## RESPONSE TO REQUEST FOR ADDITIONAL INFORMATION

### APR1400 Design Certification

Docket No. 52-046

RAI No.: 399-8510  
SRP Section: 15.06.05 – Loss of Coolant Accidents Resulting From Spectrum of Postulated Piping Breaks Within the Reactor Coolant Pressure Boundary  
Application Section: 15.06.05  
Date of RAI Issue: 02/03/2016

Figure 4-1. Containment Pressure

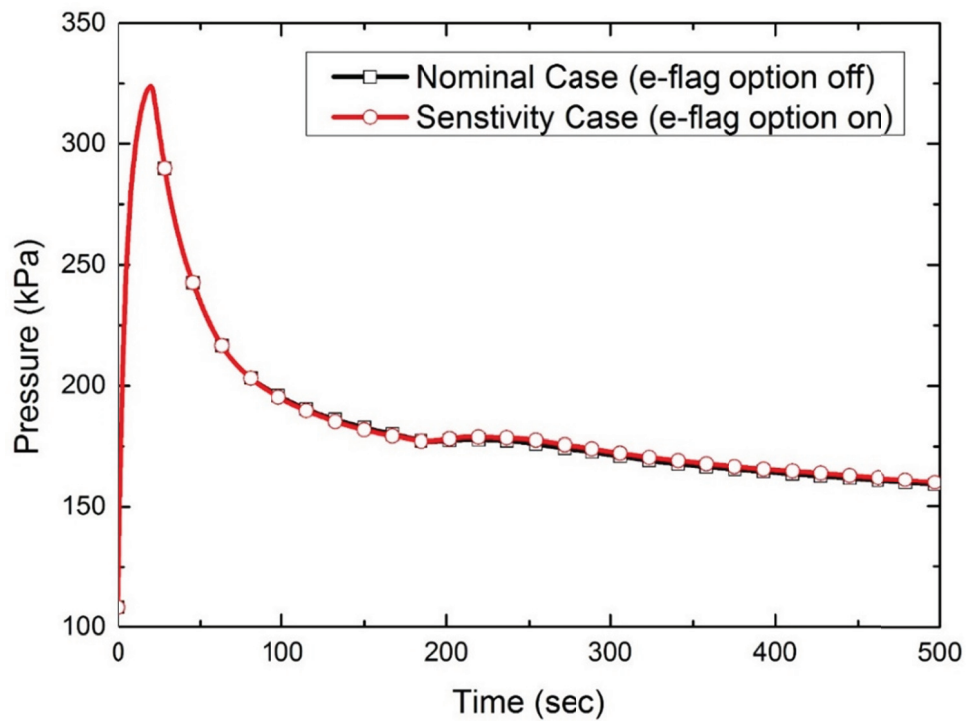
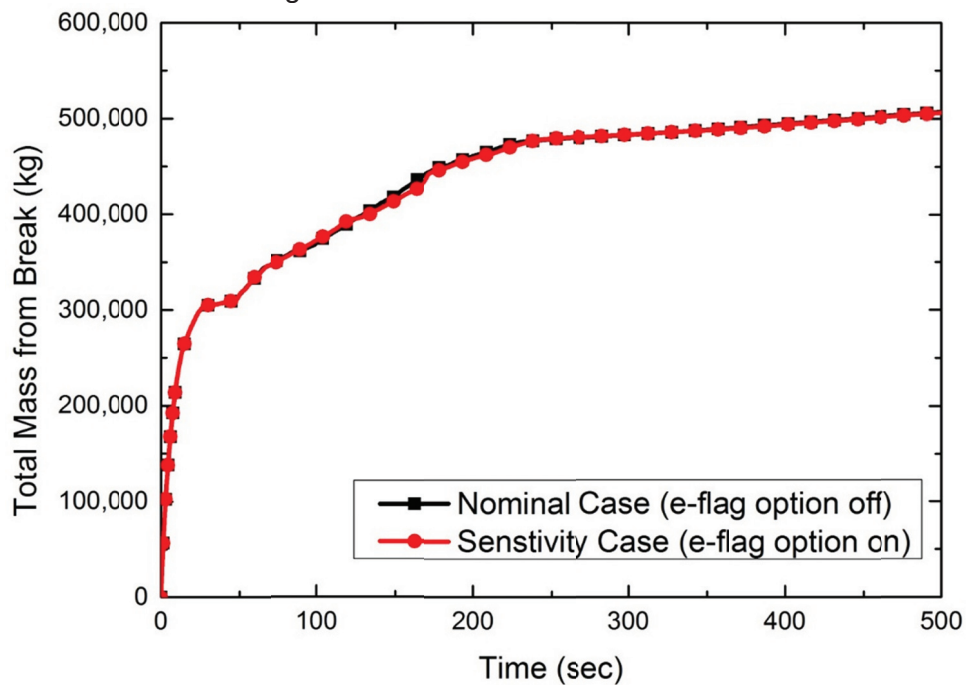
3. In the LBLOCA Topical Report, it is stated that the break flow is underpredicted for the LOBI experiments. There are multiple critical flow models in RELAP5/MOD3.3 for subcooled and saturated critical flow. Please specify which correlation was used in each flow regime. For example, was the Henry-Fauske (recommended) or the default Ransom-Trapp model used? What discharge factors were used in the chosen model and how were they determined?
4. It is well known that RELAP5 convects an incorrect amount of energy into the downstream volume connected to a junction. There is a junction flag (the e flag) that can be used to correct this. This is only an issue at the breaks where the pressure change across the junction is large.

Provide justification that break flow is correctly treated in this regard. Otherwise, containment pressures will be too low.

A sensitivity study of the e-flag option in the junction at the break was performed for the plant base case to evaluate the effect of the e-flag junction. Figure 4-1 shows the containment pressure with activated e-flag option and de-activated e-flag option, respectively. Containment pressures for those two cases do not have significant differences. Discharged mass with de-activated e-flag option is larger than that with activated e-flag option at 500 sec, by 0.2 %, as shown in Figure 4-2, thus it can be considered negligible. Therefore, it is confirmed that the e-flag option does not have a significant effect on the calculation for the amount energy of the downstream volume.

Figure 6-2. Effect of Biot Number on Suggested Surface Node Size

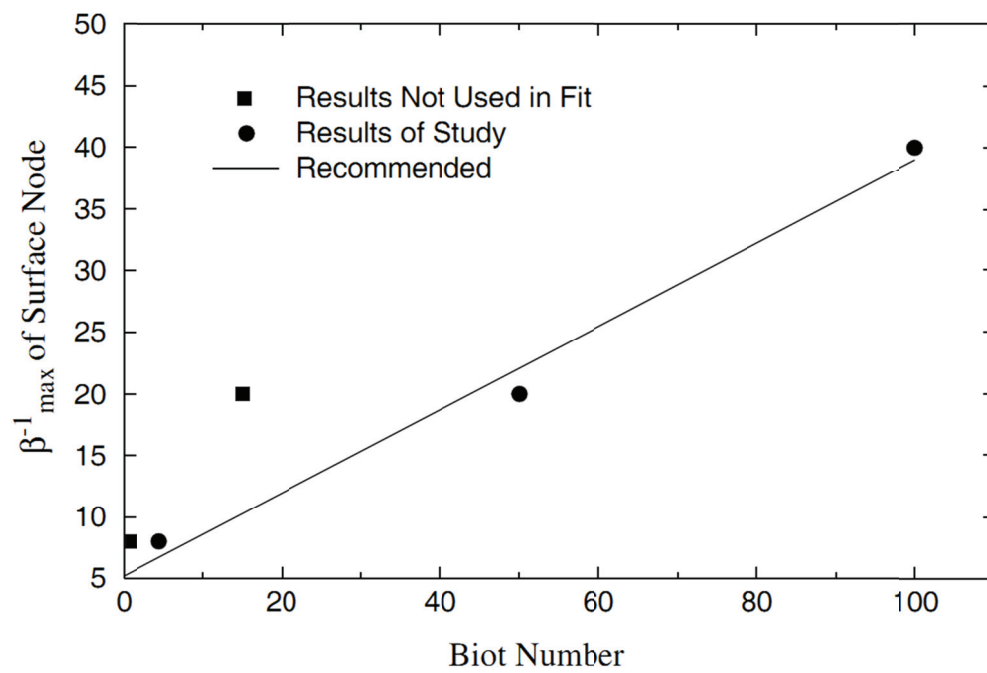
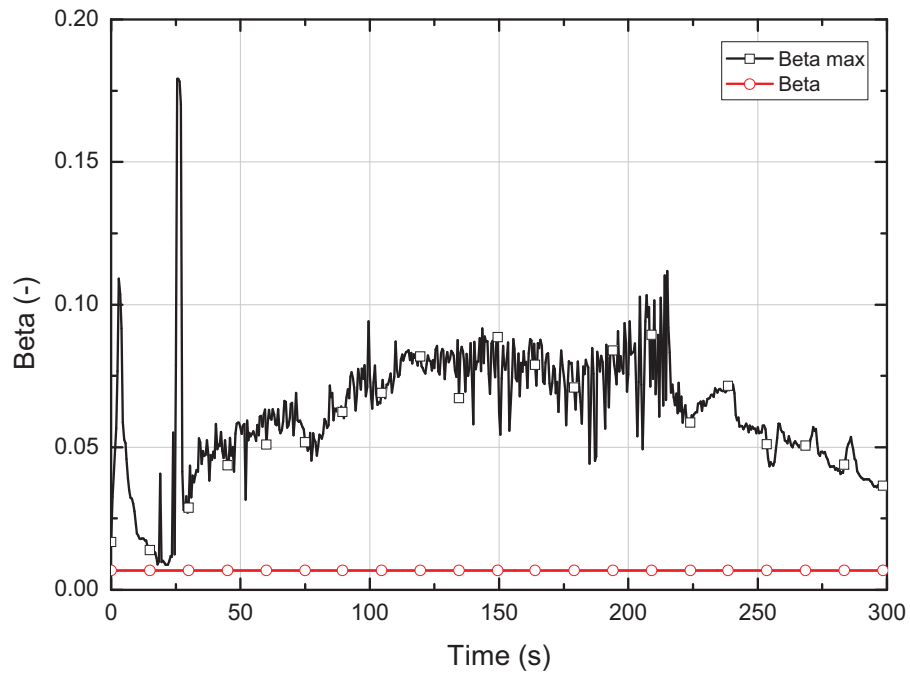
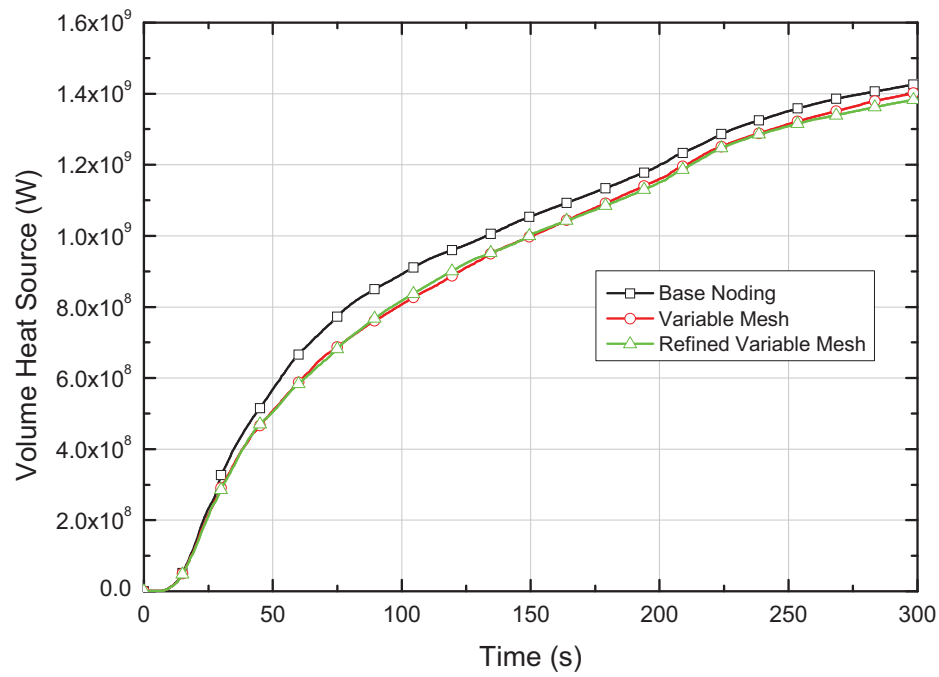
6. The modeling of the reactor vessel in the downcomer region and the thermal shield on the other side of the downcomer are critical to the prediction of downcomer filling during the refill and reflood phases. Since rapid temperature transients caused by fluid heating (or cooling) the walls initially only affects the surface of the metal and does not involve all of the metal mass. It is crucial to choose a "good" mesh spacing to capture accurately these effects. There are modeling guidelines based on the component Biot Number in the RELAP5-3D manuals to provide help on the development of an accurate mesh spacing.

Please provide a discussion of the adequacy of the mesh size selected for the analyses.

Where h is the convective heat transfer coefficient, L is the thickness of the wall, and k is the thermal conductivity of the wall material. The Biot number has a significant effect on the mesh size, and the line in Figure 6-2 shows the recommended maximum relative surface node size ( $\beta_{max}$ ). The equation for the recommended maximum surface node size is given by:

In the calculation for the APR1400 plant, the current mesh interval size is allowable since the surface node ( $\beta = \frac{1}{2} \delta_1 / L$ ,  $\frac{1}{2} \delta_1$  is one half of the first mesh interval size, L is the wall thickness) is always lower than  $\beta_{max}$  during the transient as illustrated in Figure 6-3.

Through the sensitivity study for mesh size of the downcomer wall, it is confirmed that the current noding transfers more heat to the fluid than the variable mesh (Figure 6-5). However, the differences are not significant. And, more heat transferred to the fluid is conservative from the viewpoint of downcomer boiling. Consequently, the current nodalization for the downcomer wall of the APR 1400 plant as shown in Figure 6-1 is used for the LBLOCA analysis.

Figure 7-1. Calculation Result of Intact Hot Leg Fluid Temperature for APR1400

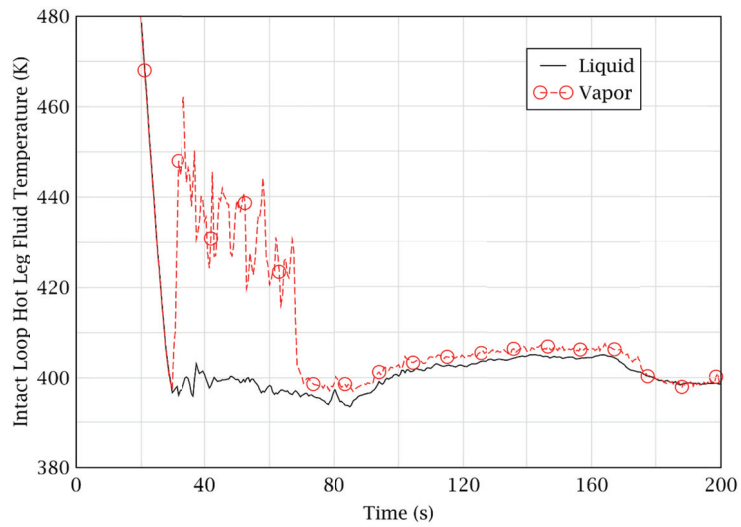
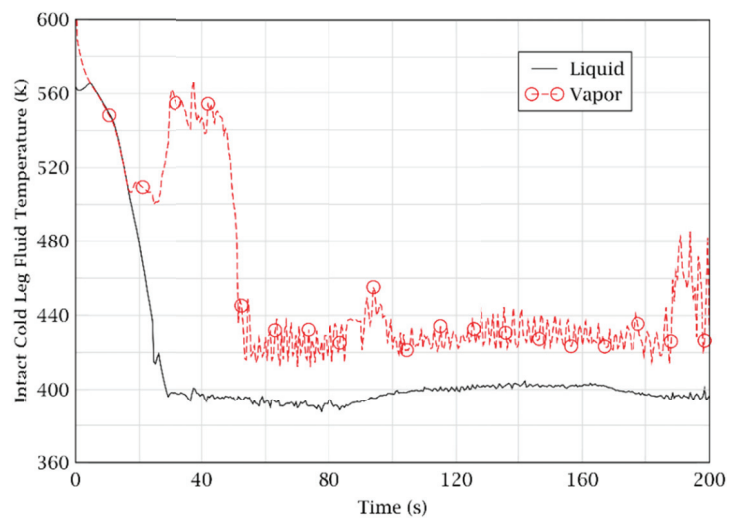
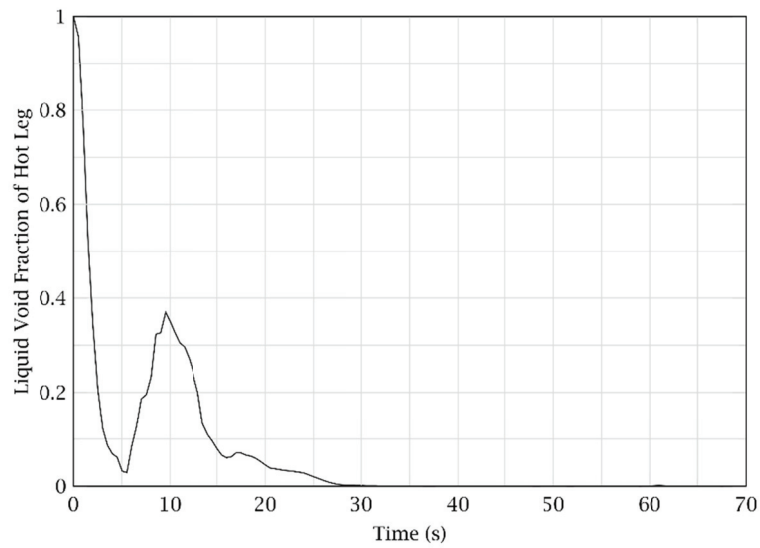
7. For the LOBI experiments discussed in the LBLOCA Methodology Topical Report, late in the transient, the RELAP5 based Engineering Model predicts 150K superheat in both hot legs and the intact loop cold leg. This seems to be unrealistically high.

Is the same level of vapor superheat seen in the full plant model? If so, are there modeling adjustments that can be made to reflect more closely the experimental data? How was this uncertainty handled in the final evaluation?

Figure 7-1 and Figure 7-2 show the calculation results of the intact loop hot and cold leg fluid temperatures for the APR1400, respectively. The reflood period initiates about 30 sec after the break, and superheated vapor comes out from the core, and superheated vapor comes out until 70 sec. However, the temperature difference between the liquid and vapor phases in Figure 7-1 is smaller than the 150 K observed in the LOBI assessment results, and the vapor temperature eventually drops to a liquid temperature at about 70 sec after the break because the core water level is increased. The cold leg fluid temperatures also show similar behavior, but the temperature difference is bigger than that of the hot leg because of the reverse heat transfer phenomenon in the steam generator.

The LOBI A1-66 test was designed to investigate the thermal hydraulic behavior of the system during the blowdown and refill periods, and the core inlet safety injection flow rate is not enough to cause entrainment of droplets to the hot leg. It makes superheated vapor in the hot leg. Superheated vapor continuously flows in from the core, whereas inflow of liquid phase is almost zero at about 30 sec after the break as shown in Figure 7-3. At this time the code calculates the liquid temperature as saturation temperature and vapor temperature as superheated temperature, all of which is coming from the core. For the cold leg in the LOBI assessment results, the temperature difference of liquid and vapor phases increases at 18 sec after the break because the safety injection from the SIT starts at this time. The liquid temperature drops below the saturation temperature because of the low temperature of the SIT injection water, whereas the vapor temperature maintains saturation temperature.

Figure 9-1. Truncation Mass Error Fraction for APR1400 Plant and LOFT L2-3 Test

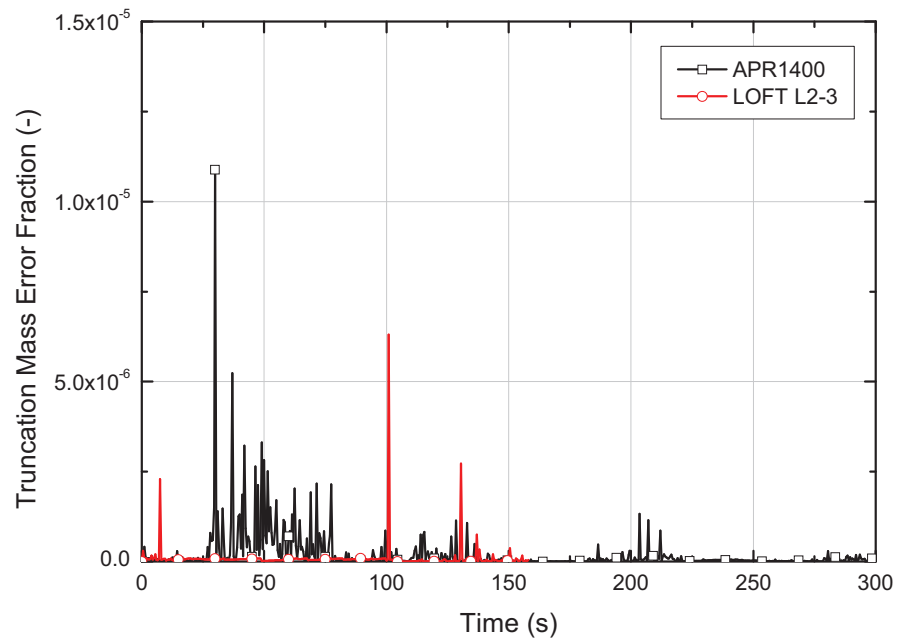
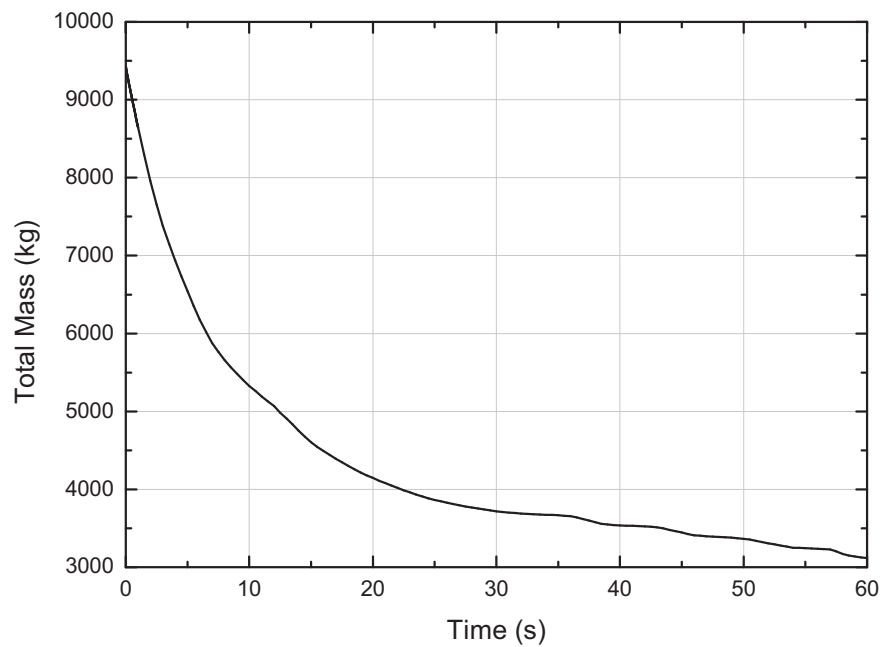
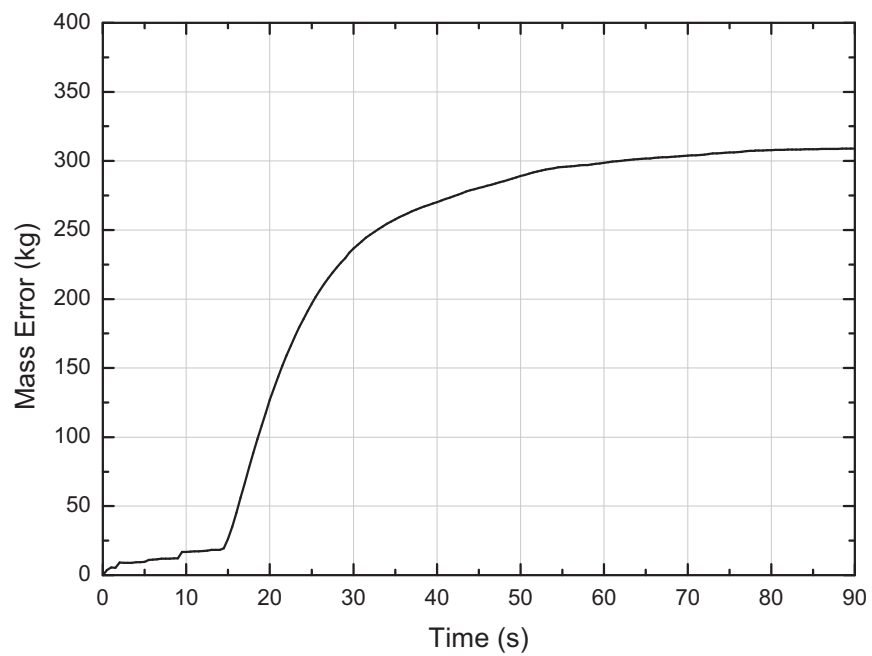
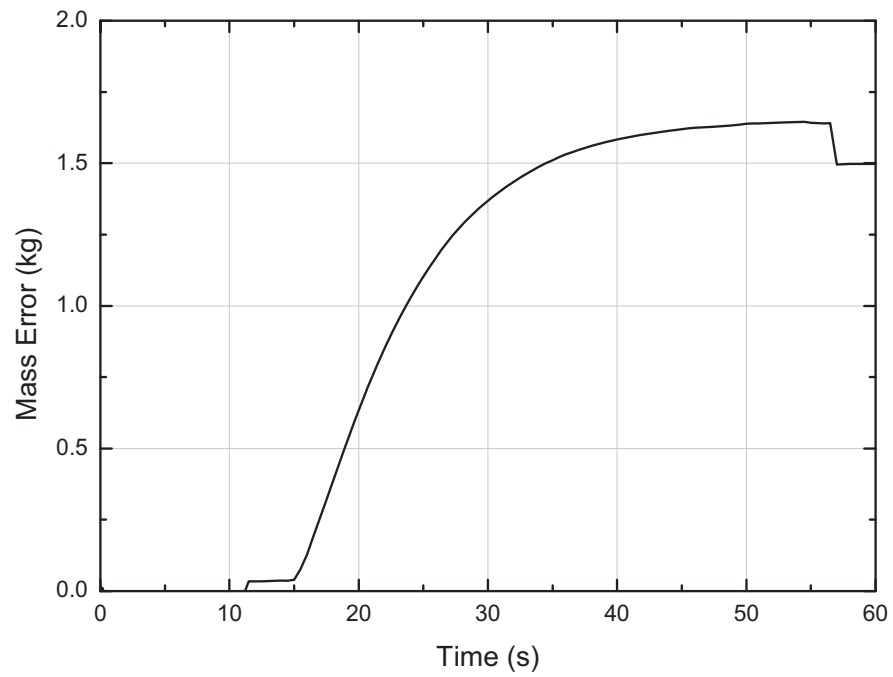
9. In the analysis of the LOFT test in the LBLOCA topical report the applicant notes: "For all calculations, this accumulated liquid in the core is larger than the amount obtained by subtracting the expelled liquid amount out of the downcomer from the delivered liquid amount to the downcomer. This implies that a portion of the liquid in the downcomer is carried to the core by the core up-flow behavior." RELAP5 has a tendency to accumulate "mass error" particularly in two-phase regions. When the mass error is large relative to the change in mass of interest, it often masks the actual behavior of the system. The mass error can usually be reduced by using smaller time steps and/or renodalizing the region where the mass error is occurring.

Provide justification that the mass error for full plant evaluation as well as the LOFT test results ensure that the conclusions remain correct and that mass error is not influencing the conclusions.

In the RELAP5 code, two types of mass errors are computed as described in Reference [9-1]. If either  $\epsilon_m$  or  $\epsilon_{rms}$  is larger than  $8 \times 10^{-3}$ , the time step is repeated with one half of the time step size. The maximum of  $\epsilon_m$  or  $\epsilon_{rms}$  for all volumes can be found in minor edit (ERRMAX, current estimate of the truncation mass error fraction). The mass error fraction for the APR1400 plant and the LOFT test calculation are shown in Figure 9-1. As shown in Figure 9-1, the mass error is always lower than  $8 \times 10^{-3}$  during the transient.

Figure 9-2 and Figure 9-3 show the mass errors in all systems for the APR1400 plant and the LOFT test calculation. The total system masses at the start of each calculation are about [ ]<sup>TS</sup> respectively, and the total system masses at the end of each calculation are about [ ]<sup>TS</sup> respectively. The mass error for the APR1400 plant and the LOFT test are represented in Figure 9-4 and Figure 9-5. Since the mass error for the plant and the LOFT test calculation (300 kg and 1.5 kg respectively) are very low compared with total system mass, the effect on the calculation result is negligible.

Figure 10-1. Figure 4.4-1 of the reference [10-1]

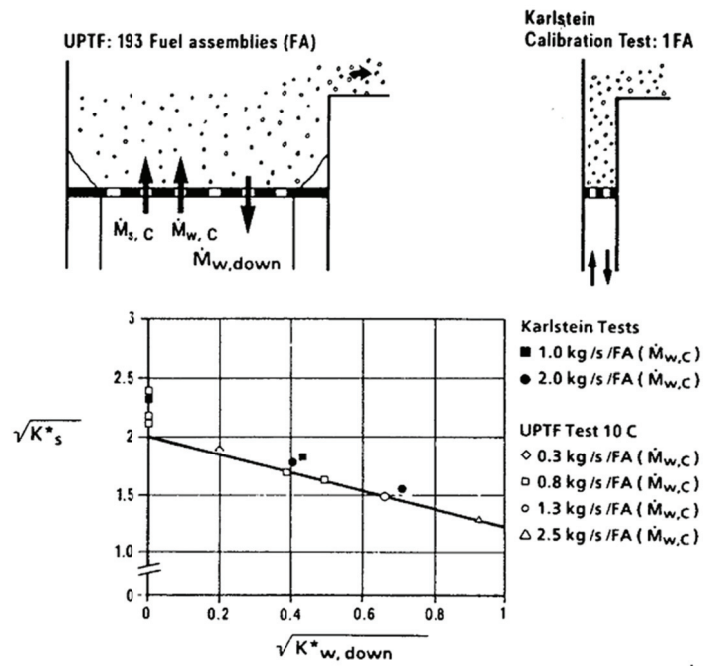
10. During the early reflood phase, it is stated that the entrained liquid travels to the upper plenum where it is de-entrained and accumulates in the upper plenum where it subsequently flows down through the lower power (cooler) assemblies. This sets up a three-dimensional flow pattern (essentially a Natural Circulation flow path up the hot assemblies and down the cooler assemblies).

Since RELAP5/MOD3.3 is a set of one-dimensional models, how is the model constructed to capture these three-dimensional phenomena and how is the model qualified/validated?

In general, experiments on CCFL are well correlated with the Kutateladze number as shown in Figure 10-1. Most important thing to check is the limiting gas velocity,  $v_{s,Limit}$ , above which no liquid fall back is possible.
